Access Compliance Report

(Curb Ramps)

Intersection ID: 22295	Main Street: HUCKLEBERRY_RD	Cross Street: KRONOS_PL	Location:	N
ADA ID: 70561EE08DE2	Ramp Type: BlendTrans1	Initial Pass/Fail: Pass	Overall Compliance: No	Severity Score: 10.25
Codes/Mitigation Info/Possible Solution		Field Measurements/Component Compliance

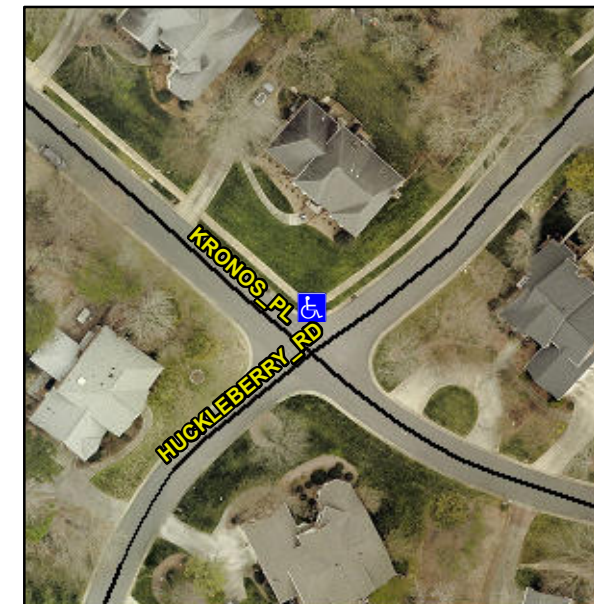
Not Found, R304.5.3, R305

Compliance	Description	Data	Compliance	Description	Data
N/A	Ramp Length (in)	48.0	Yes	BlendTrans Slope (%)	4.0
Yes	Ramp Width (in)	81.0	No	BlendTrans XSlope (%)	3.4
N/A	Flare Type LT	None	N/A	Flare Type RT	None
N/A	Flare Slope LT (%)	N/A	N/A	Flare Slope RT (%)	N/A
N/A	Flare Traversable LT?	N/A	N/A	Flare Traversable RT?	N/A
Yes	Landing Length (in)	50.0	No	DWS Provided?	No
Yes	Landing Width (in)	63.0	N/A	DWS Contrast?	No
Yes	Landing Slope (%)	2.0	N/A	DWS Length (in)	N/A
No	Landing X Slope (%)	2.1	N/A	DWS Full Width?	No
N/A	Landing Curb? (Y/N)	No	N/A	DWS Offset (in)	N/A
N/A	Shared Landing?	No			
Yes	Gutter Ponding?	No	Yes	Gutter Slope (%)	1.9
Yes	Gutter Lip Ht (in)	0.0	Yes	Gutter X Slope (%)	1.6
N/A	Painted X Walk1?	No	N/A	Painted X Walk2?	No
	X Walk 1 Direction	To SW		X Walk 2 Direction	To SE
	X Walk 1 Width (in)	N/A		X Walk 2 Width (in)	N/A
	X Walk 1 Slope (%)	4.2		X Walk 2 Slope (%)	0.1
	X Walk 1 X Slope (%)	0.7		X Walk 2 X Slope (%)	2.9

N/A	Ramp inside XWalk1?	N/A	N/A	Ramp inside XWalk2?	N/A
	Road Slope (%)	2.1		Clear Space?	Yes
	Road X Slope (%)	3.8	N/A	Clear Space to XWalk (in)	N/A
Yes	Any Obstructions?	No	Yes	Storm Grate/Utility Hazard?	No
	Obstruction Type			Storm Grate/Utility Type	
		N/A			N/A
			Yes	Surface Condition? (G/P)	Good
			No	Curb Slope (%)	6.9

Remove & Replace Curb Ramp With Two New Directional Ramps or Equivalent.
